## **8.4. Planning Proposal PP5/20 - 52 Alfred Street South, Milsons Point**

To present to Council the assessment of a Planning Proposal which seeks to amend the North Sydney Local Environmental Plan 2013 (NSLEP 2013) as it relates to land at 52 Alfred Street South, Milsons Point following its review by the North Sydney Local Planning Panel which is included.

The North Sydney Local Planning Panel (NSLPP) considered the Assessment Report on 9 December 2020, and resolved not to support the progression of the Planning Proposal to a Gateway Determination. The NSLPP agreed with the reasons for not supporting the Planning Proposal outlined in this report.

**FIGURE 16: Extract from View 1 (page 62 of VIA) Indicative view impact of**

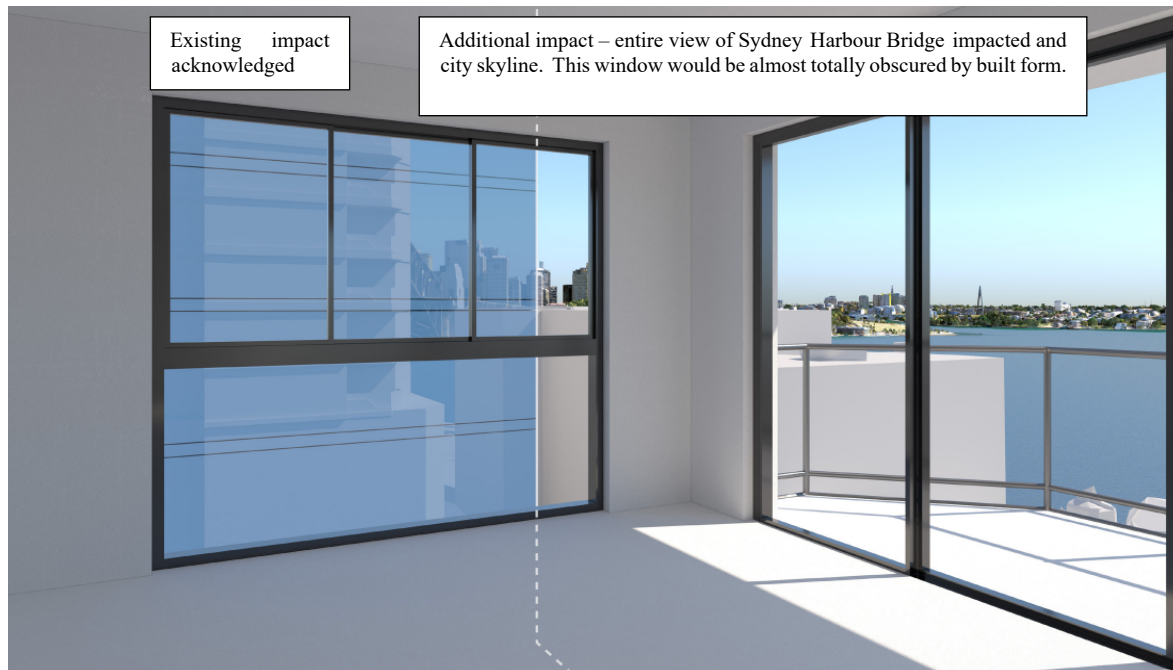
Figure 16: A significant portion of the view from the living room window has been obscured by the proposed development. The view impact assessment also shows the mass of the proposed built form oblique rather than in solid form which incorrect interprets the actual impact that would occur. It is recognised that the existing building to the south of the site does have an impact on the existing view, but a partial view of Sydney Harbour Bridge and the skyline is retained, as existing.
